**A14**  
**Cambridge to Huntingdon  
improvement scheme**  
Development Consent Order Application

Comments on Deadline 8 Submissions

Development Consent Order Application  
Comments on Deadline 8 Submissions

**HE/A14/EX/145**

Figure 1 Comparison of the ES result and SBS Option 3 result as reported by SBS

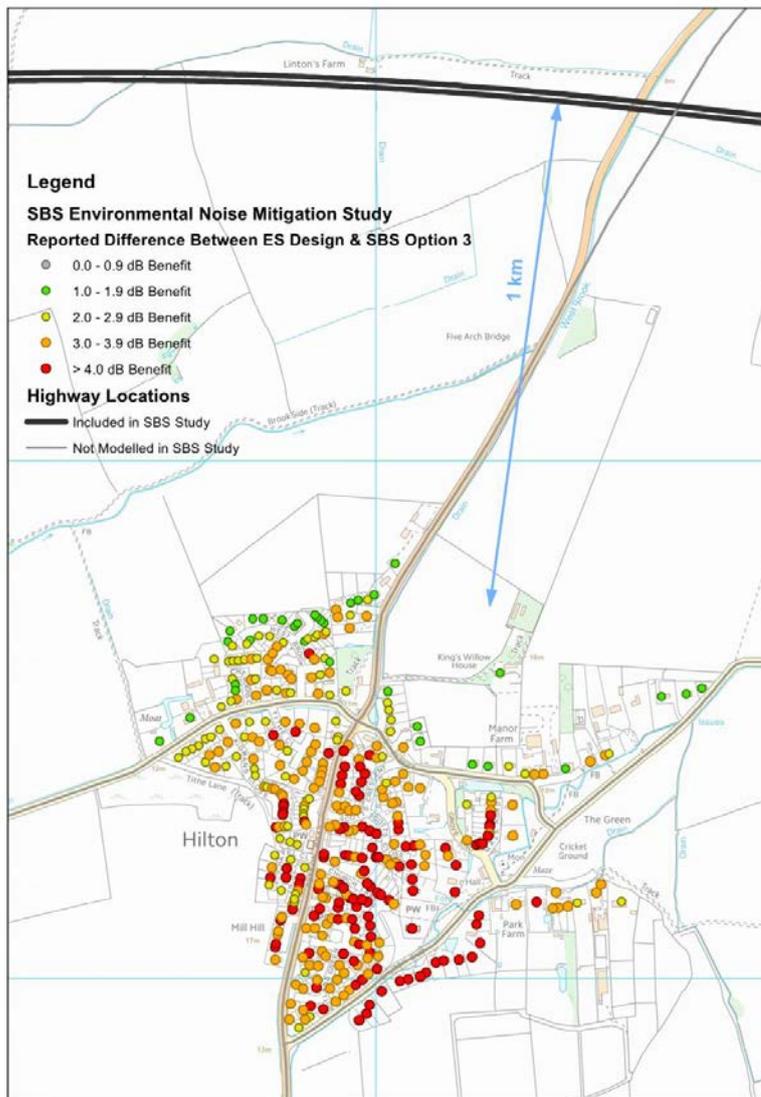
- 2.7.3 The SBS model suggests +4 dB improvement with their 'Option 3' design (4m high bund with 4m barrier extension to the east) over the ES design. It shows how the SBS model predicts increasingly better performance from their option as distance increases from the source. The differences range between 0dB and 6dB (mean 2.9dB, standard deviation 1.1). The large difference reported between the two mitigation scenarios is an unexpected result. A higher level of barrier performance would normally be expected at closer distances to the barrier.

- 2.7.4 Given these somewhat surprising results, Highways England sought further information from Hilton Parish Council and SBS. Further information was provided in the submission by Hilton Parish Council and the response from SBS dated 27 August 2015. A relatively long response was received but did not fully address the question as to why a substantially greater barrier effect is predicted at receptors further back from the front row properties.

Figure 2 Calculated difference between ES design and SBS Option 3 using ISO9613, as calculated by Highways England

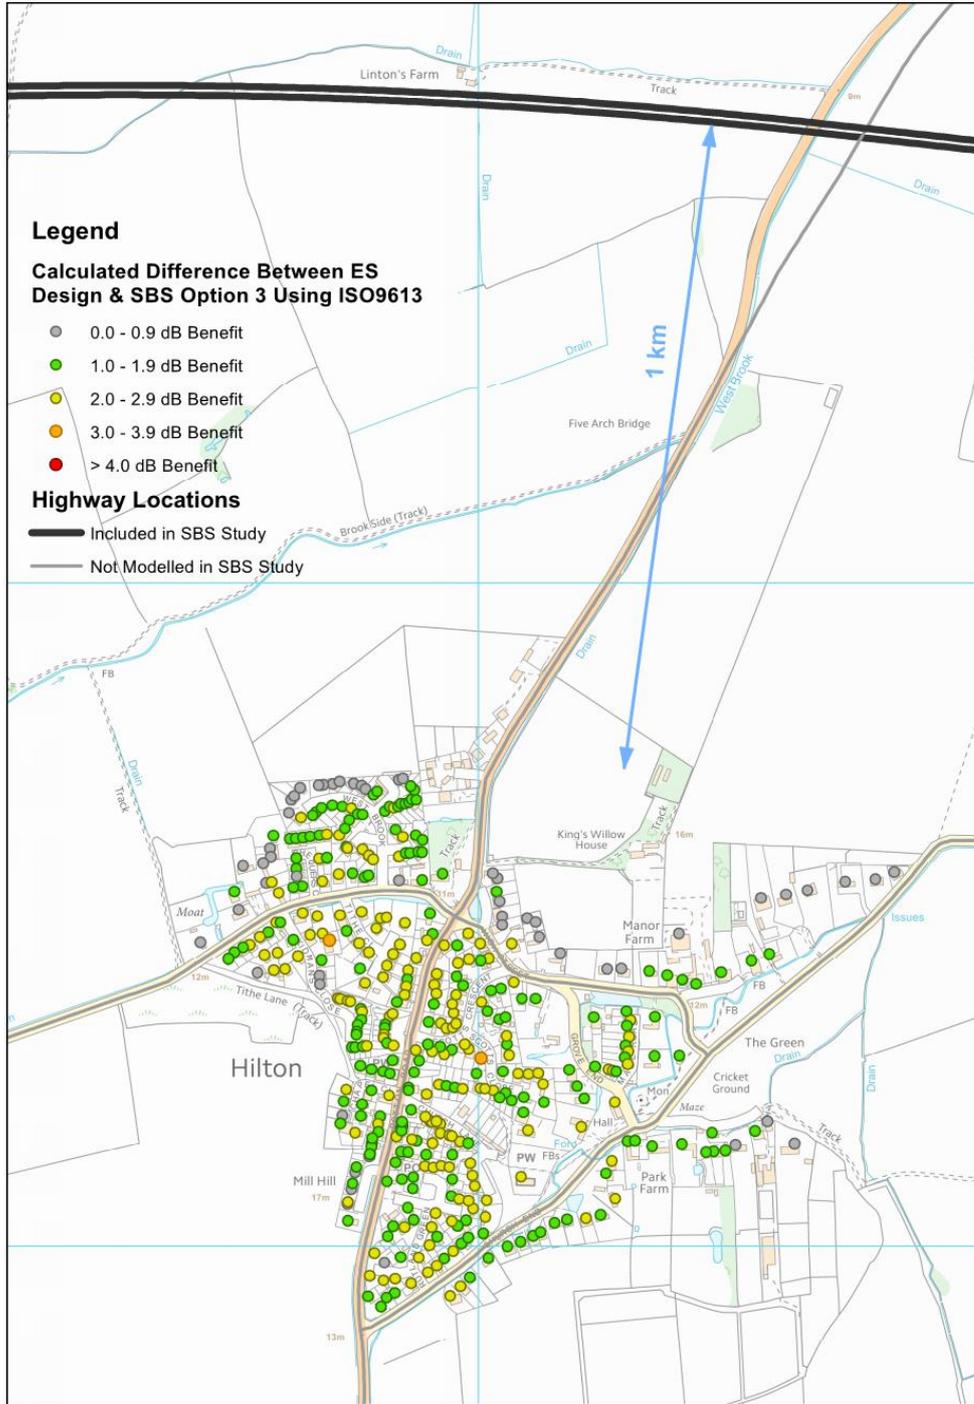
- 2.7.6 Road traffic noise from the Huntingdon Southern Bypass has been predicted using the ISO9613 method. The results of the predictions are presented with and without the presence of intervening buildings. The results including intervening buildings are shown in Figure 2 below. It can be seen that the differences between the two mitigation scenarios are significantly lower than those reported by SBS. These differences could be explained by a number of differences in the software and the interpretation of the ISO9613. The differences between the 2m earth bund and the 4m barrier option range between 0dB and 3dB (mean of 1.7dB, standard deviation 0.6). Even though the differences are lower a similar trend emerges in that, with the inclusion of buildings, the ISO9613 predicts increasingly better performance from the SBS option behind the first row of buildings. However, Figure 3 shows the results with the presence of the intervening buildings removed. This demonstrates that the effect of the environmental noise barrier is small and uniform across the village.

- 2.7.7 SBS have claimed and continue to claim that the noise reductions reported and summarised in Figure 1 are attributable to their recommended 4m noise barrier. However, the ISO9613 is a complex method that is being used outside its normal scope. For example, the method will account for the barrier losses for multiple screens (in this case the environmental noise barrier and the intervening buildings) using complex algorithms for multiple propagation paths over and around multiple barriers. In simple terms this means that the barrier losses predicted and reported by SBS cannot be attributed to the environmental noise barrier itself. Rather the barrier losses are a combination of the barrier effect given by the environmental noise barrier and the intervening buildings across large distances beyond the recognised upper limit of the standard.

Figure 3 Calculated difference between ES design and SBS Option 3 using ISO9613 excluding local screening effects from buildings in Hilton as calculated by Highways England

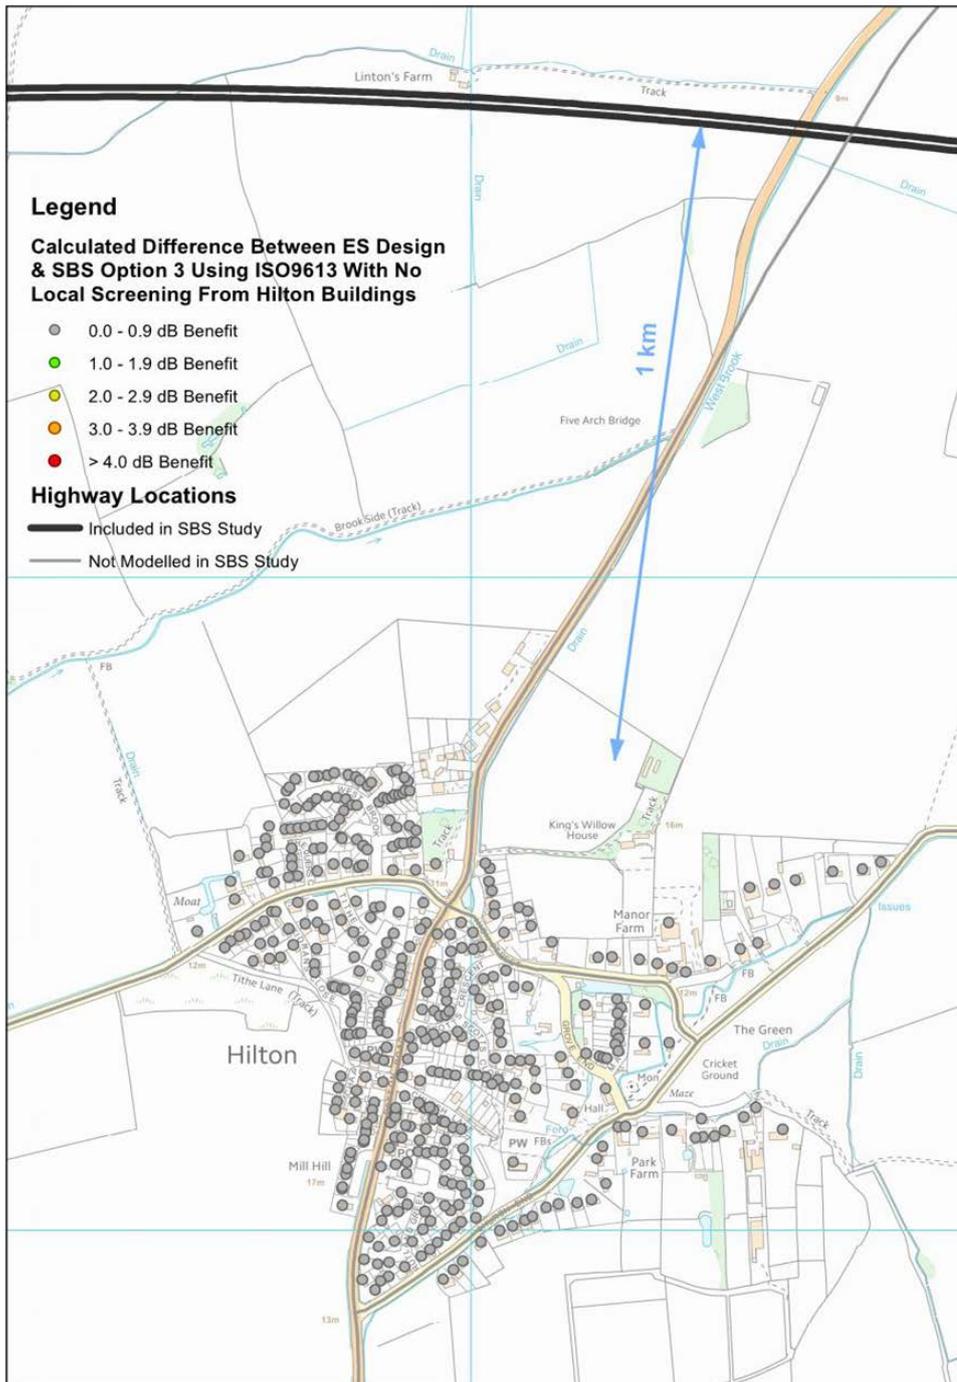
- 2.7.8 Figure 3 compares the ES Design with SBS Option 3 without any local screening from Hilton buildings results in differences of between 0.1 and 0.6 dB (mean 0.3, standard deviation 0.1). This is much closer to what that expected from the ISO barrier attenuation calculation at long distances, which for an infinite barrier would result in around 0.2 dB.

Figure 4 ISO9613 screening attenuation

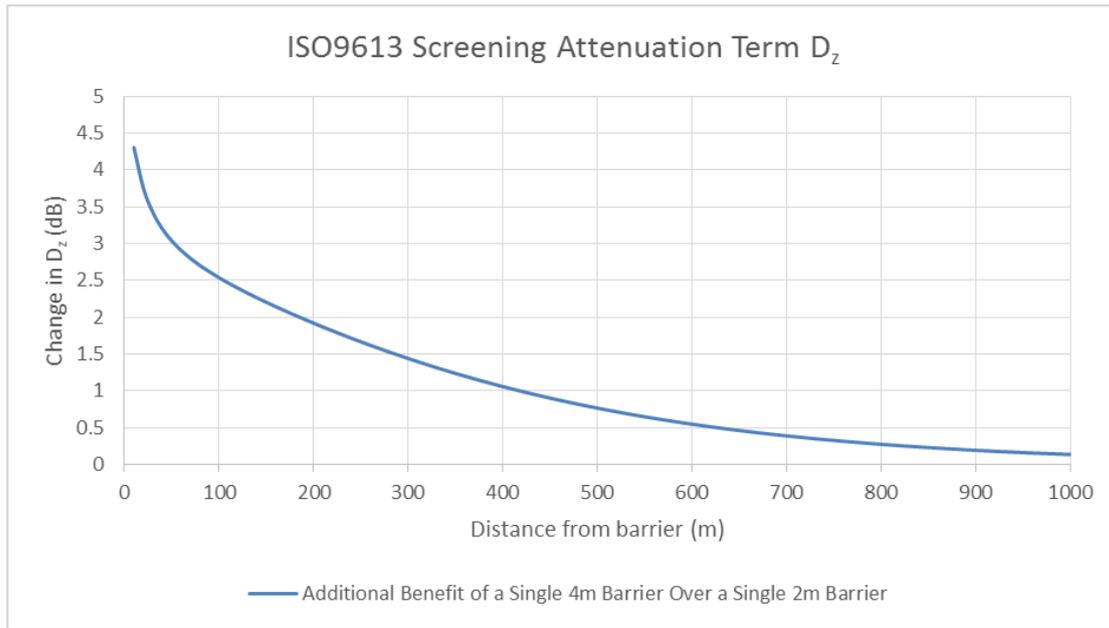
- 2.7.9 Figure 4 shows the additional screening attenuation from a 4m barrier compared to a 2m barrier predicted using the ISO9613 calculation method. This assumes an infinitely long barrier propagating over otherwise unobstructed ground. It can be seen that the effectiveness of the barrier attenuation decreases with increasing distance from the source such that the difference is less than 0.5 dB at about 600m and beyond and reduces to around 0.1 dB at around 1km, the distance between the closest properties at Hilton and the proposed Huntingdon Southern Bypass. This supports Highways England's submissions to ExA that noise barriers will have no benefit at Hilton.
